Revisions and Errata List
AISC Steel Design Guide 24, 1st Printing (Printed Edition) and March 2015 Revision (Digital Edition)
August 20, 2020

The following list represents corrections to the first printing and the March 2015 revision (digital edition) of AISC Design Guide 24, *Hollow Structural Section Connections*.

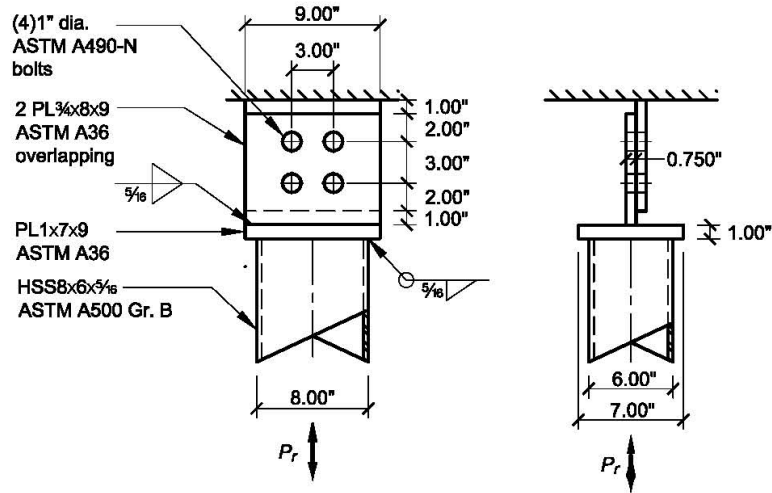
| 55 | Figure 5-9 should be revised so that the connection plate dimensions are as shown in the figure below: |
